R44 SERVICE BULLETIN SB-113

SUBJECT: Actuator Lower Bearing A185 Brackets

R44 Helicopter S/Ns 2480 & prior,
R44 II Helicopter S/Ns 14089 & prior, and
R44 Cadet Helicopter S/Ns 30022 & prior.

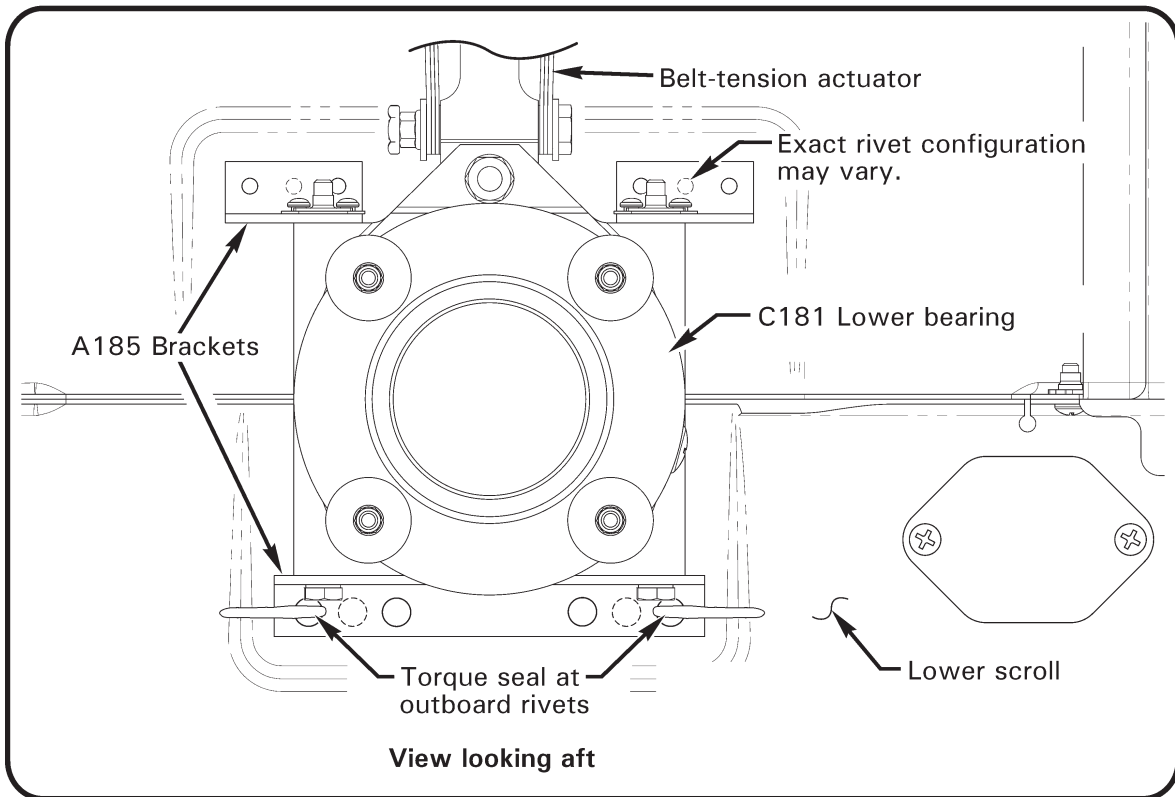
1. Refer to Figure on page 2. Visually inspect A185 brackets and verify three 5/32-inch [shank diameter] rivets attach bracket to scroll at each corner of C181 lower bearing (earlier brackets used 1/8-inch rivets and require upgrade). If there are less than (12) 5/32-inch rivets total, or if evidence of bracket looseness or fretting is found, repair scroll per R44 Service Letter SL-61 (latest revision).

MS20470AD5 universal-head rivets have minimum 0.296-inch diameter head.
MS20426AD5 countersunk-head rivets have minimum 0.282-inch diameter head.

2. On lower A185 bracket, remove any previous vertical torque seal, then apply torque seal in a horizontal stripe across both outboard rivets to lower scroll to facilitate future inspections.
